Agenda
Village of Arlington Heights
Building Code Review Board
Commissions Room
33 S. Arlington Heights Road, AH 60005
May 11, 2017
6:30 PM

BUILDING CODE REVIEW BOARD

MINUTES OF A MEETING BEFORE THE VILLAGE OF ARLINGTON HEIGHTS BUILDING CODE REVIEW BOARD

1 BASEMENT PLAN
1/4" = 1'-0"

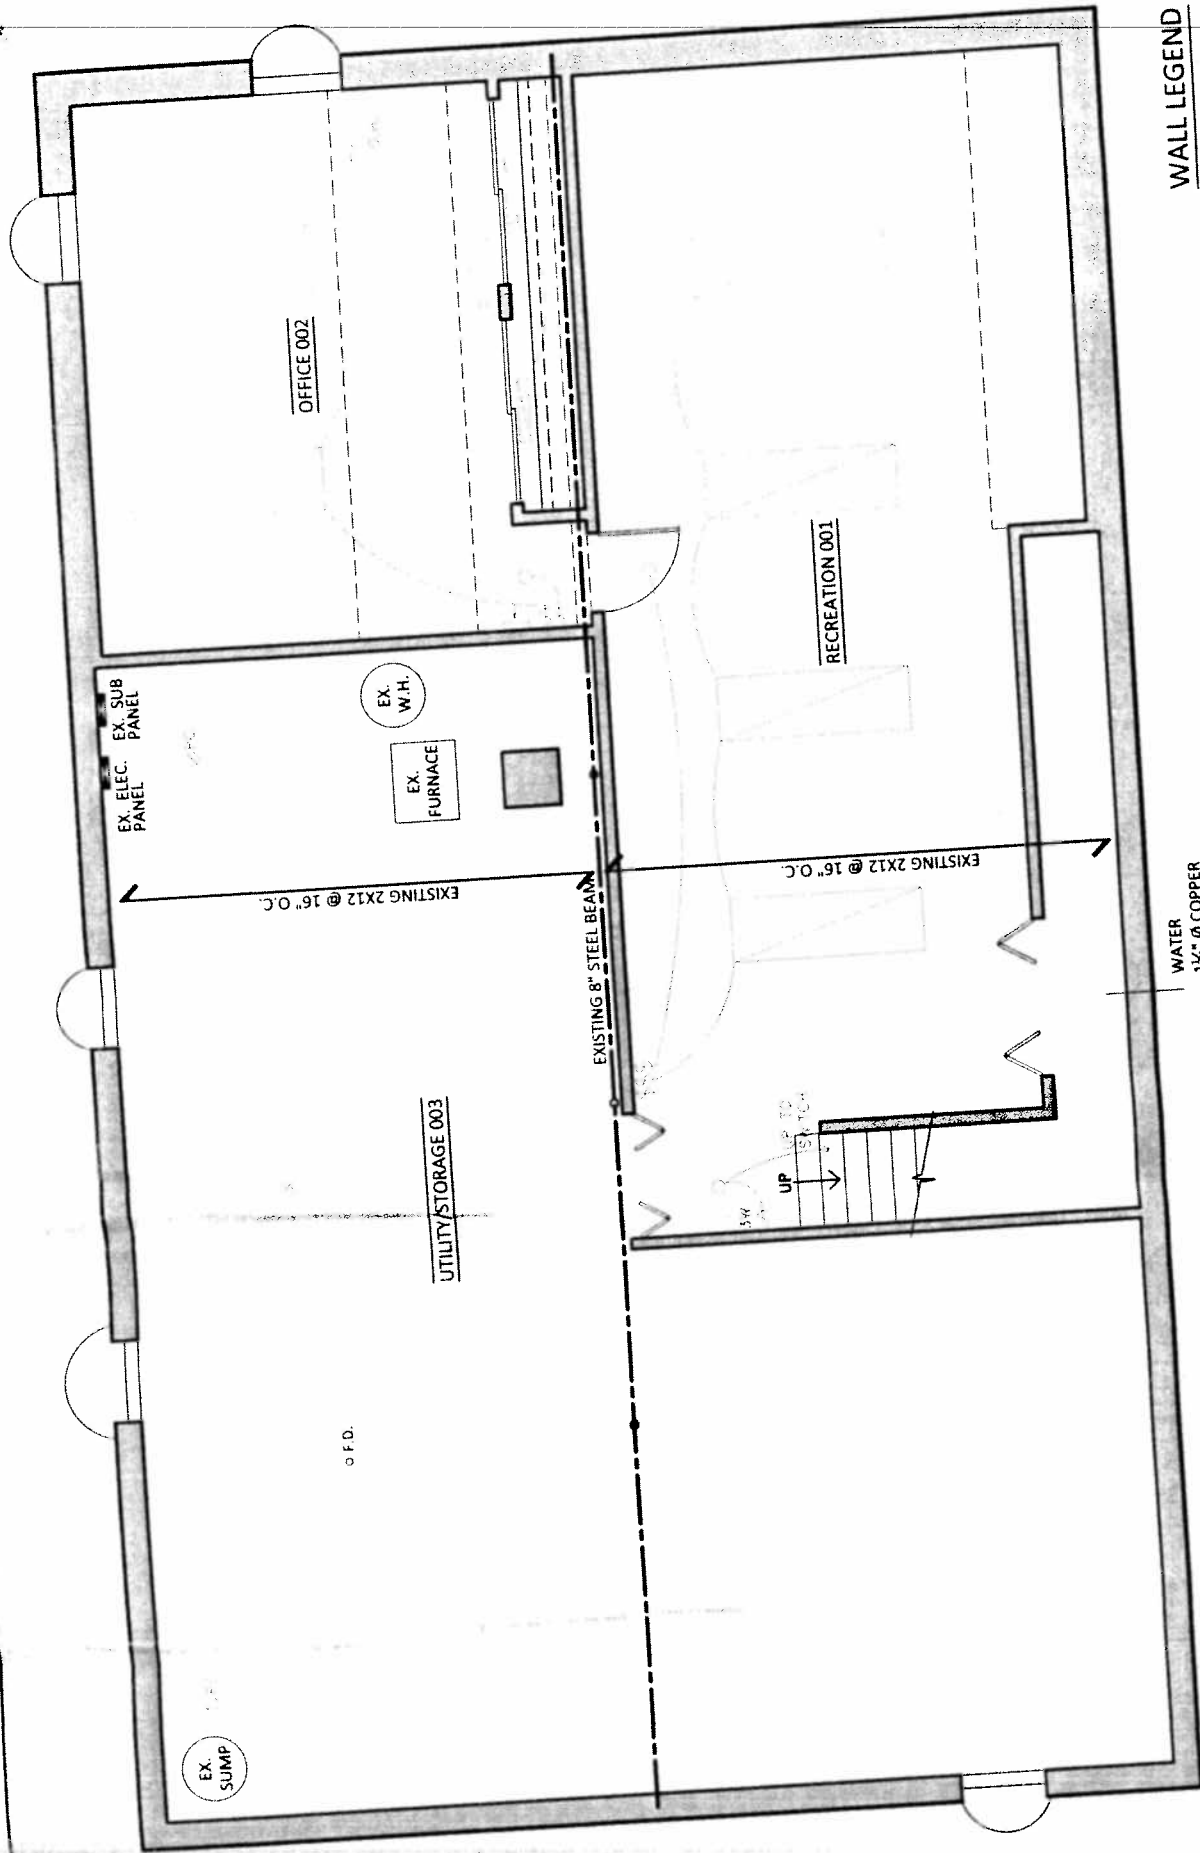
Building Services does not recommend approval of the waiver for a ceiling height lower than the Village ordinance because:

1. The space is being converted to a sleeping room which could fill up more quickly with smoke, impede rescue operations, and/or endanger inhabitants or first responders in the event of a fire and;
2. The Village amended code requires 8 foot high ceilings; the minimum ceiling height allowed in any standard national building code is 7 feet; the proposed space ceiling height is only 6'9".
